**U.S. DEPARTMENT OF ENERGY
OFFICE OF ENVIRONMENTAL
MANAGEMENT
OFFICE OF ENGINEERING
TECHNICAL EXPERTISE PROJECT 610**

**PADUCAH 2006 SITE WIDE REMEDY
REVIEW**

APRIL 13, 2006

Figure 7: Composite Contours for Technetium-99 for the Regional Gravel Aquifer at the PGDP.

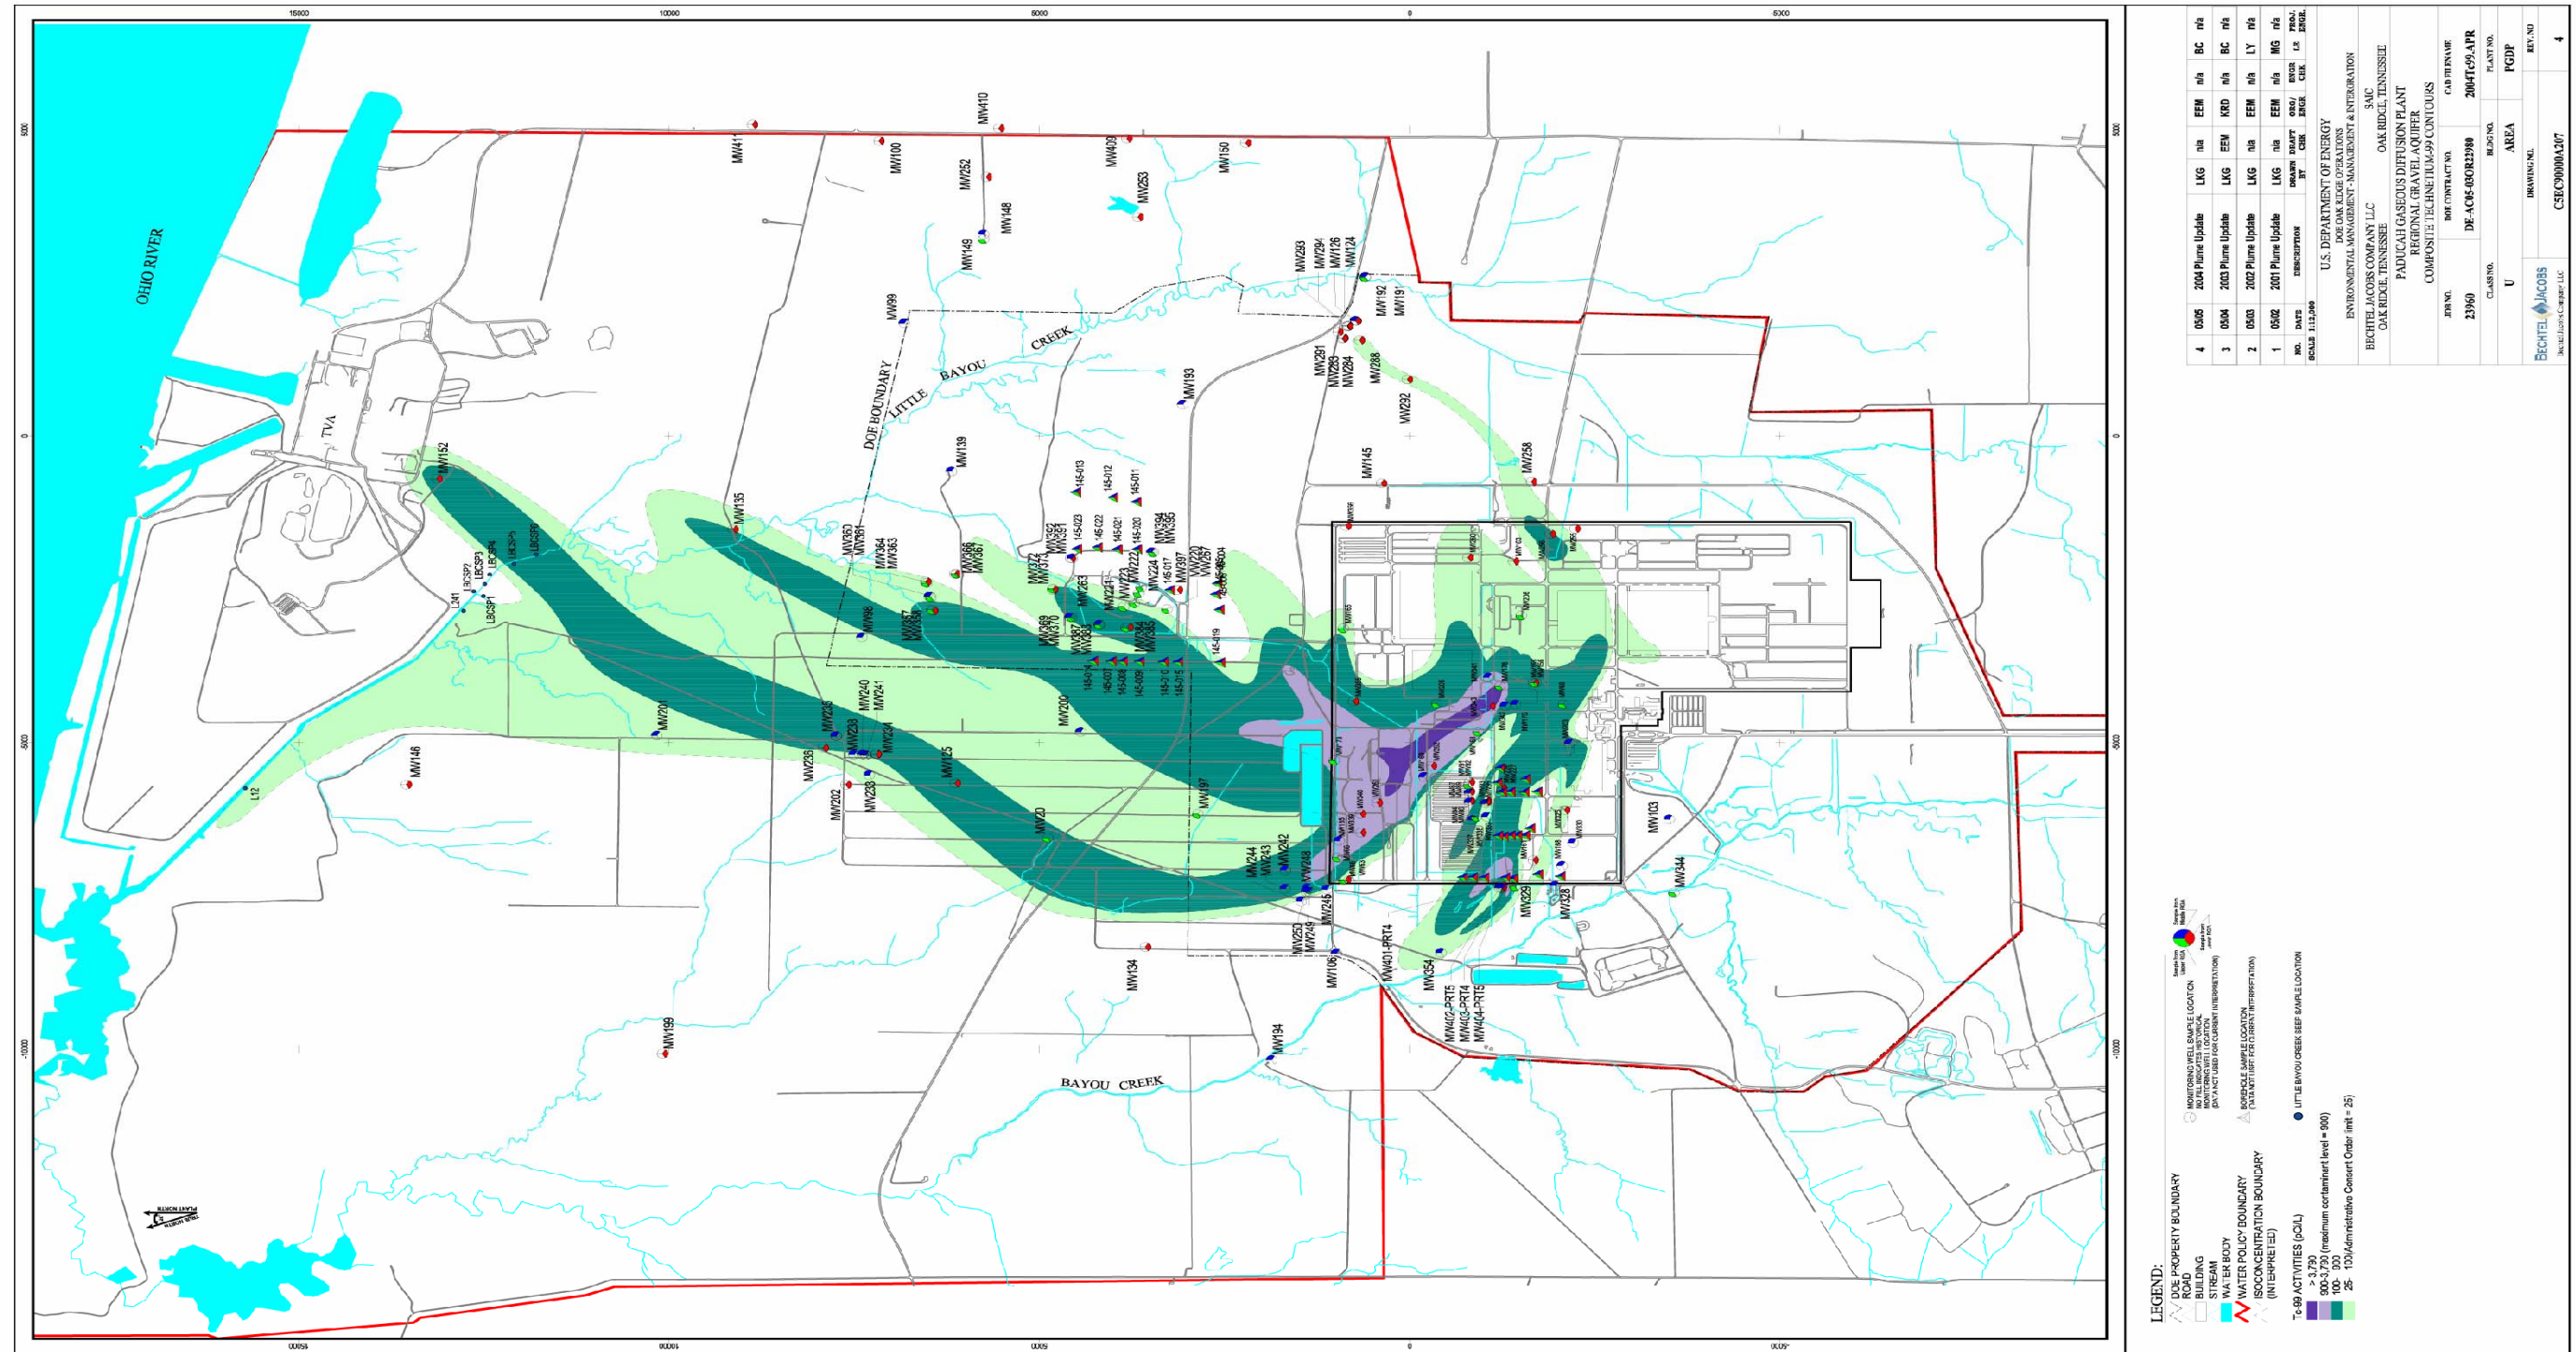
Time-trend analysis and annual updates to the groundwater plume maps generally indicate that the Tc-99 plume (Figure 7) moving northward offsite is stable (i.e., levels remain uniform or decrease). A few monitoring wells in the RGA exhibit increasing levels of Tc-99 in the northwest and northeast plumes. Concentrations of Tc-99 exceeding 900 picoCuries/liter (pCi/L) associated with the primary source area, Building C-400 and environs, are within the DOE property boundary. [Note: 900 pCi/L is the EPA-established target cleanup level, or maximum concentration limit (MCL), for Tc-99, assumed to yield a dose equivalent to the 4 millirem per year (mrem/yr) for beta-emitting radionuclides.] Therefore, at the time of this review, DOE can demonstrate compliance against the groundwater MCL for Tc-99 for offsite plume migration to the northwest and northeast.

Contour maps for the TCE (Figure 8) and Tc-99 (Figure 7) plumes are somewhat misleading in their depictions. Contaminant contours shown on site maps are dashed and closed around the most northerly offsite and westerly onsite monitoring wells, indicating that the plumes terminate before reaching the Ohio River, Big Bayou Creek, and the western DOE property boundary. The CSM for Paducah (Figure 5) reflects an understanding that both the TCE and Tc-99 plumes discharge to the Ohio River and/or associated river deposits, but they do not appear to be monitored just upgradient of these discharge areas. There are no monitoring wells at these locations. On the western side of the facility, particle tracking of the southwest plume (Figure 6) indicates that a portion of the plume will likely migrate toward Big Bayou Creek. Insufficient monitoring wells exist in the western and northwestern areas adjacent to the facility to monitor plume migration for accurate depiction, compliance, remedy performance, and public health reasons.

Since Tc-99 is a nonreactive tracer with a long radioactive decay half-life, it lends itself to the simplest of predictive models: water particle transport that is not complicated by processes of decay, retardation, dispersion, etc. The Review Team recommends that predictive flow modeling of the Tc-99 plume be conducted (including calibration and verification) sufficient to confirm that the Tc-99 plume migration is stable in the out years. The benefits of predictive modeling are (1) to provide defense-in-depth that offsite risk to groundwater degradation from potential plume expansion is controlled and decreasing, and (2) to confirm that remedy evaluation for Tc-99 source and plume treatment beyond the existing pump and treat systems is unwarranted.
